## Addendum #6

Project: MILWAUKEE PUBLIC LIBRARY GOOD HOPE MILL ROAD

Proj. #: 170044.00

BID PACKAGE #4 – TEKNION

WR-3 – Updated dimensions

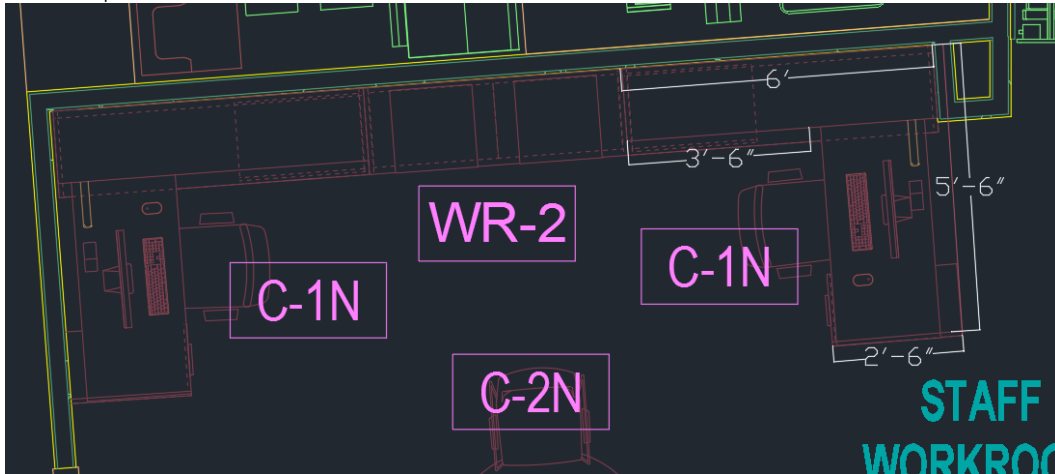
WR-2 is calling out for a 30x48 and a 24x72, but the WR-3 is calling out for a 30x72 and a 24x48 – could you please confirm that is how you would like it or if I need to make the WR-3 a 30x48 and a 24x72 please?

**ZAS CLARIFICATION:** WR-2 and WR-3 should be 30"x66" at the main work surface, and the entire return side should span 72" as it spans below the main work surface top. The return side itself is 48" long on WR-3 and 42" on WR-2 (verify in field) with a 30" lateral file below. WR-2 receives the bench with cushion on top in addition to this.
